Comments and Responses for Drainage Department (Lot 764RP DD 120)

I refer to DSD referenced memo dated 3 January 2025 regarding the captioned submission and reply comments:

Stormwater Drainage Design

Report No.: **LD/L764 RP/DS02**
Date: **19/1/2025**

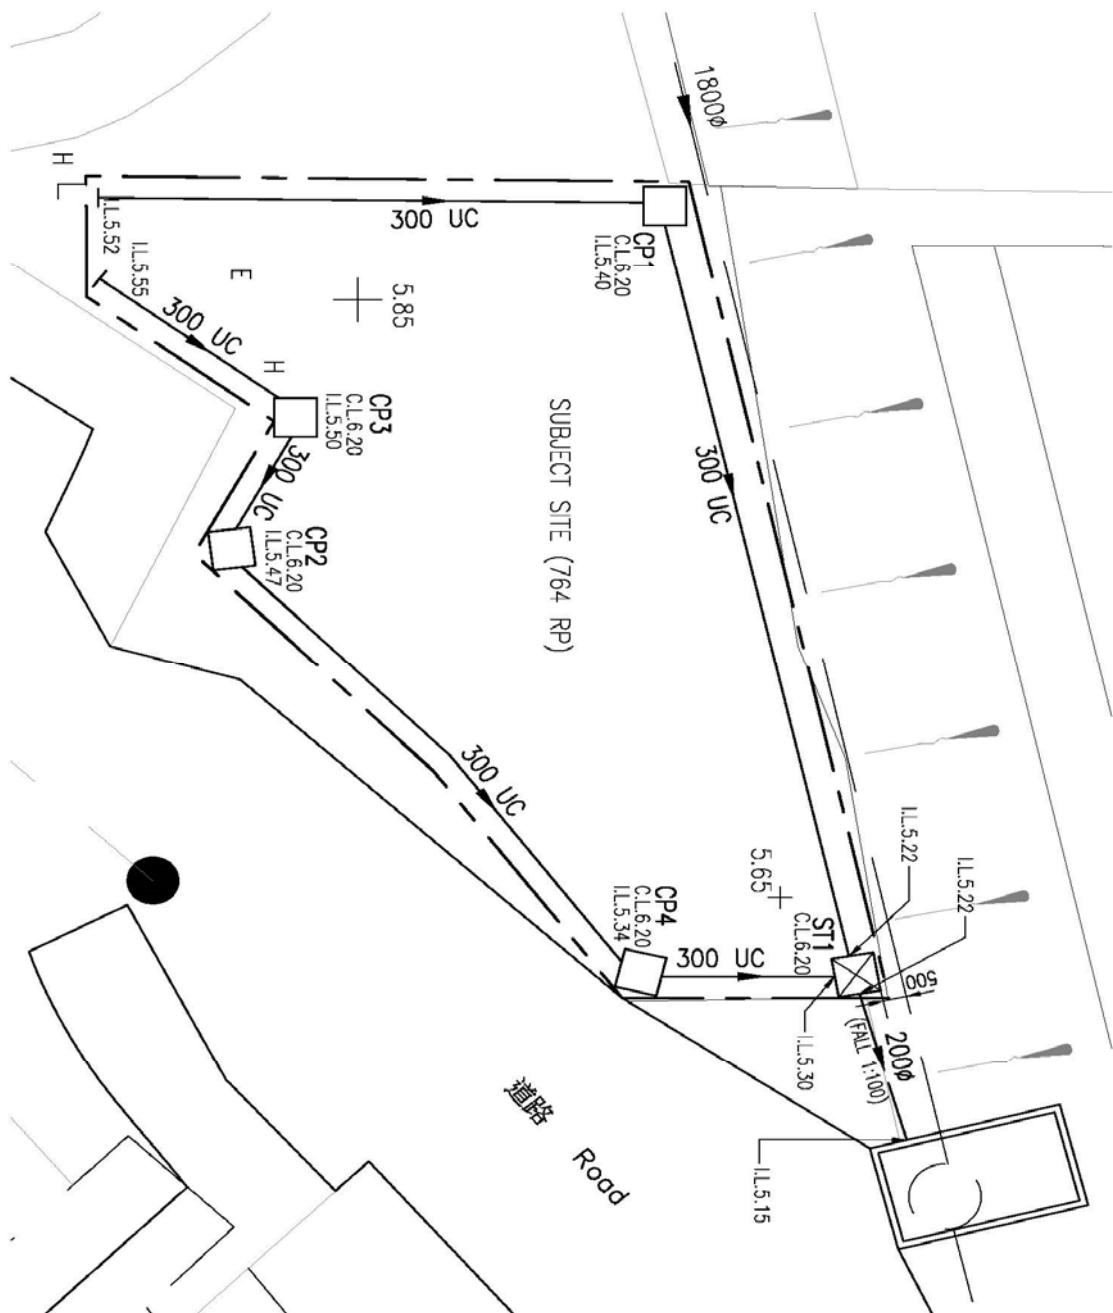
II. Please justify the size of the 200mm underground pipe with hydraulic assessment while it conveys the flow of two 300 UC upstream.

Please refer to the attached hydraulic calculation

Refer to Drawing No. LD/L764RP/D01(B), the alignment of proposed channel is indicated to suit for the proposed development. The proposed diversion comprise of 200mm precast concrete pipe. The pipe size and the capacity check are as follows.

The capacity (0.047 m³/s) of the proposed pipe is larger than the highest capacity of Return Period 1 in 50 (0.03 m³/s). Therefore, used 200mm precast concrete pipe is adequate for catchment Area of A.
